Service Bulletin

American Honda Motor Co., Inc.

2001 GL1800/A Speedometer Replacement

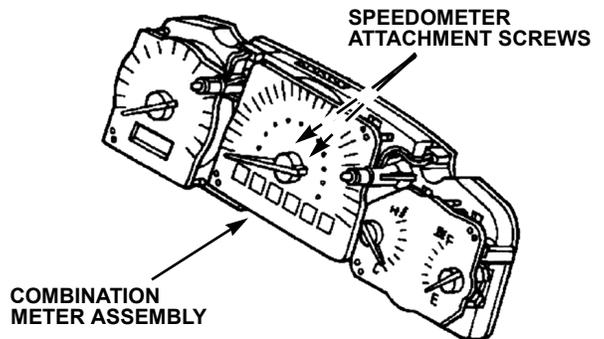
The speedometer faceplate may warp from extended exposure to direct sunlight. This can produce intermittent sticking of the speedometer needle. A replacement speedometer is now available to correct this condition.

1. Remove the combination meter assembly (see page 19-14 in the Service Manual).
2. Disassemble the combination meter assembly.
NOTE: It is not necessary to remove the LCD assembly.
3. Remove the two speedometer attachment screws located on the back side of the combination meter circuit board.

4. Remove the speedometer.
5. Install the replacement speedometer.
6. Reassemble the combination meter assembly and reinstall it in the reverse order of disassembly.
